Nomination Form
Anadromous Waters Catalog

Region Southeastern USGS Quad(s) BERING GLACIER A-3, ICY BAY D-2 & D-3
 Anadromous Waters Catalog Number of Water Body 191-20-13400-2033-3005 (-4035)
 Name of Water Body Lydick Creek USGS Name Local Name
 Addition Deletion Correction Backup Information

Nomination # <u>25-598</u>	<u>[Signature]</u> Fisheries Scientist	<u>9/24/2025</u> Date
Revision Year: <u>2026</u>	<u>[Signature]</u> Habitat Operations Manager	<u>9/24/25</u> Date
Revision to: <input checked="" type="checkbox"/> Atlas <input checked="" type="checkbox"/> Catalog	<u>[Signature]</u> AWC Project Biologist	<u>8 Sept 2025</u> Date
Revision Code: <u>C-9, A-1</u>	<u>P. R.</u> GIS Analyst	<u>10/3/2025</u> Date

191-20-13400-2033-3005-4035

Map #3

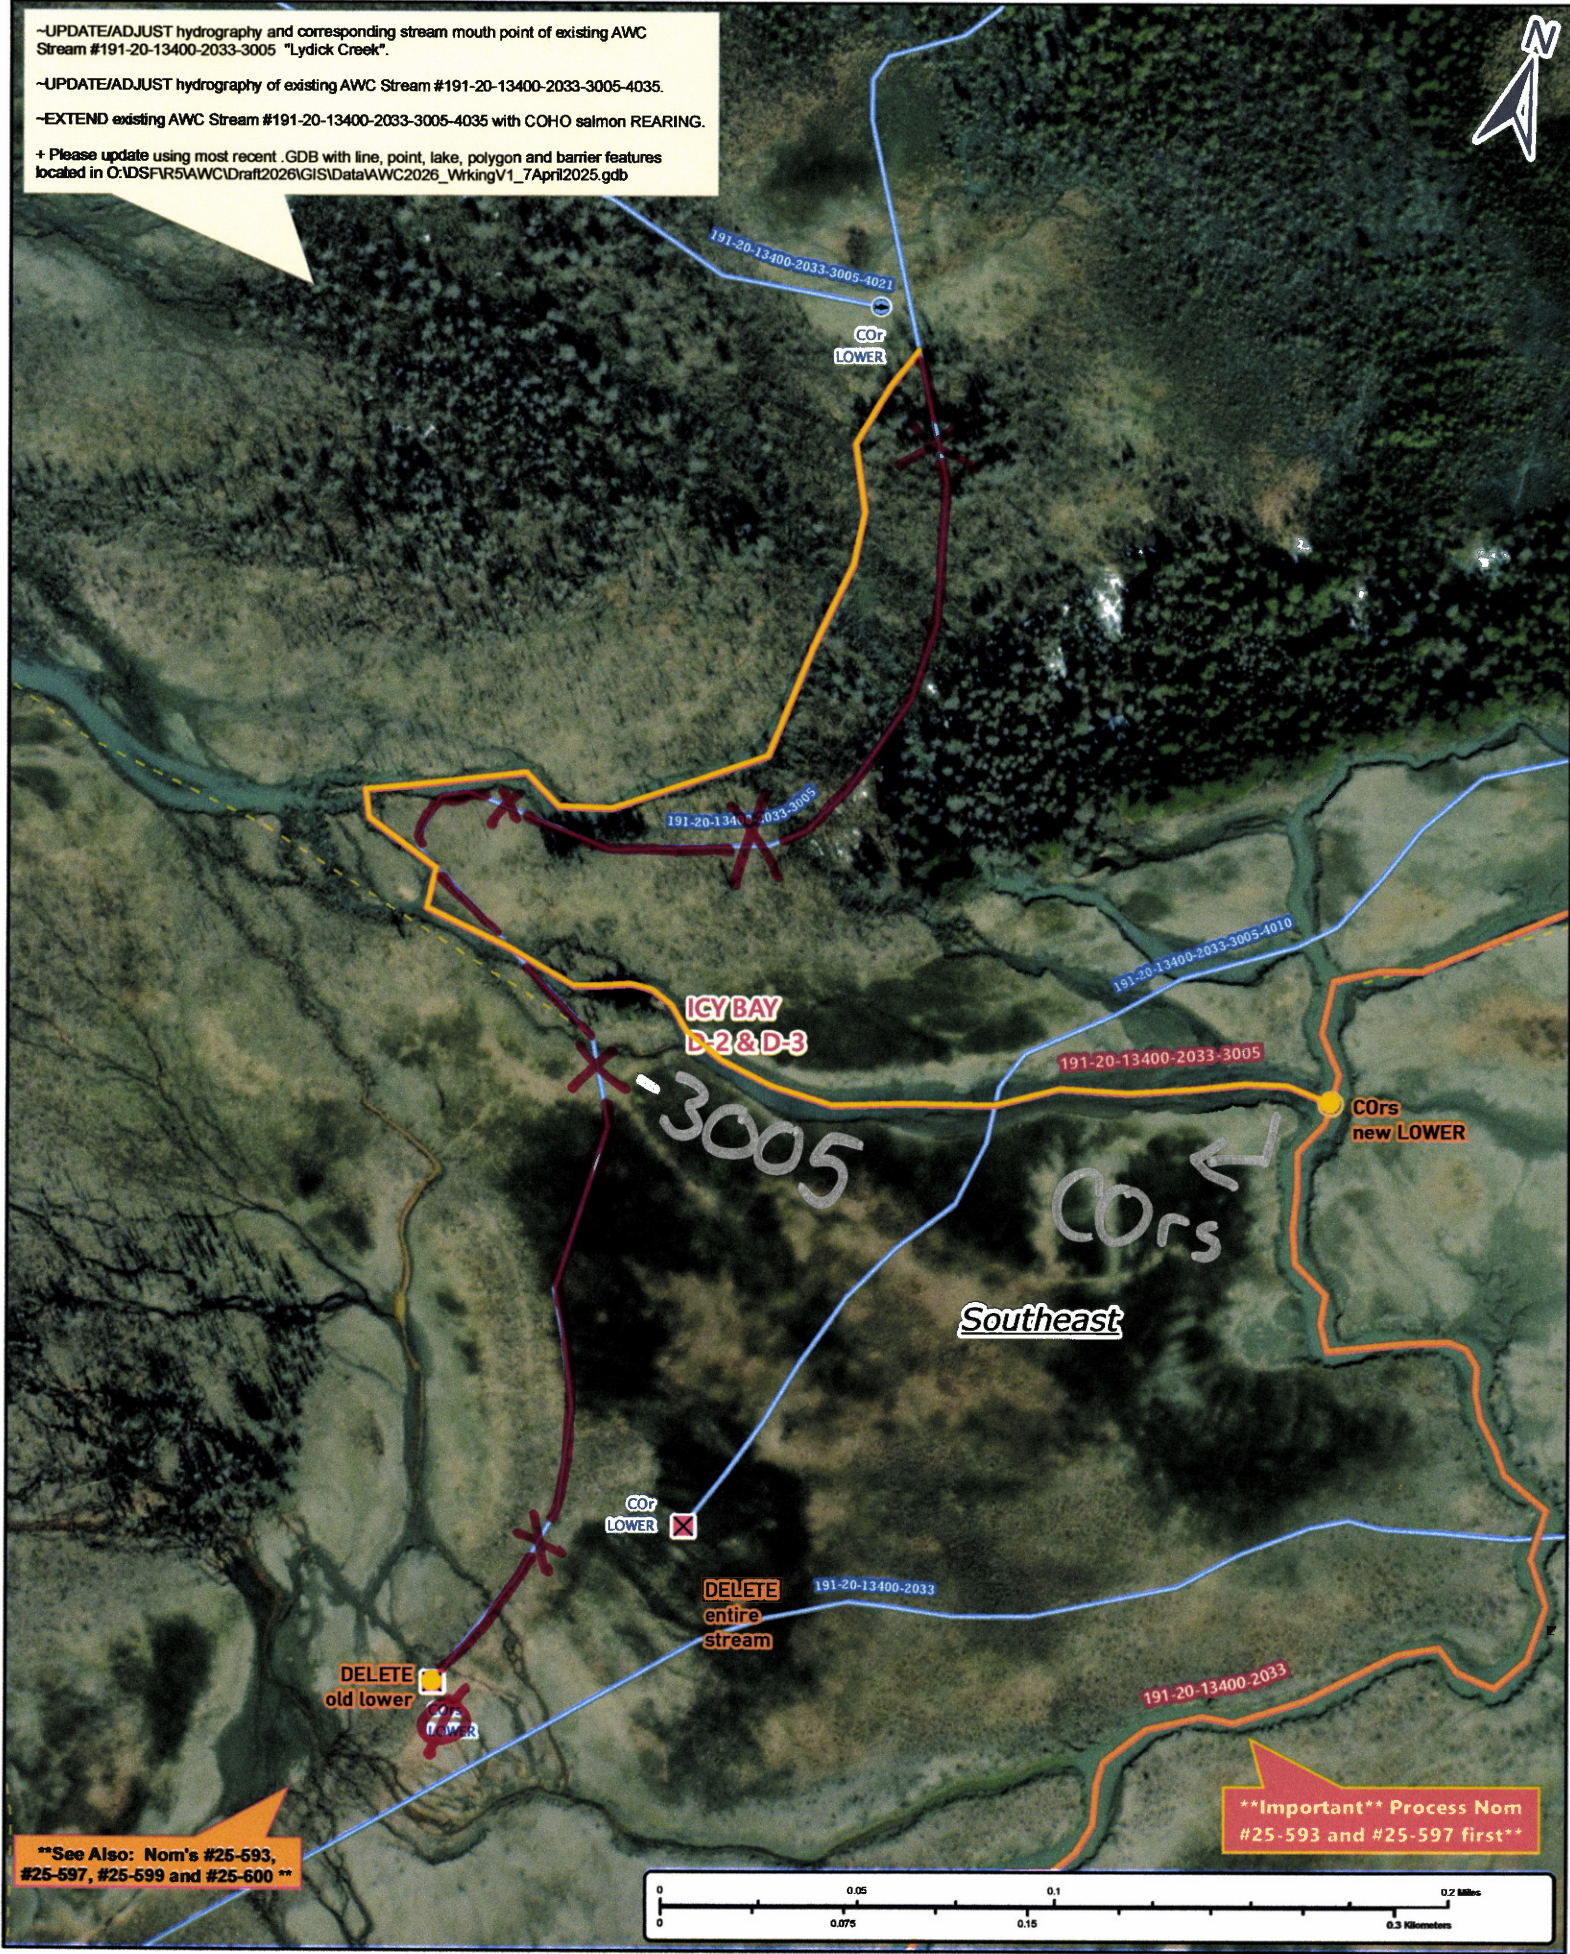
-UPDATE/ADJUST hydrography and corresponding stream mouth point of existing AWC Stream #191-20-13400-2033-3005 "Lydick Creek".
 -UPDATE/ADJUST hydrography of existing AWC Stream #191-20-13400-2033-3005-4035.
 -EXTEND existing AWC Stream #191-20-13400-2033-3005-4035 with COHO salmon REARING.
 + Please update using most recent .GDB with line, point, lake, polygon and barrier features located in O:\DSFR5AWC\Draft2026\GIS\Data\AWC2026_WorkingV1_7April2025.gdb

****Important** Process Nom #25-593 and #25-597 first****
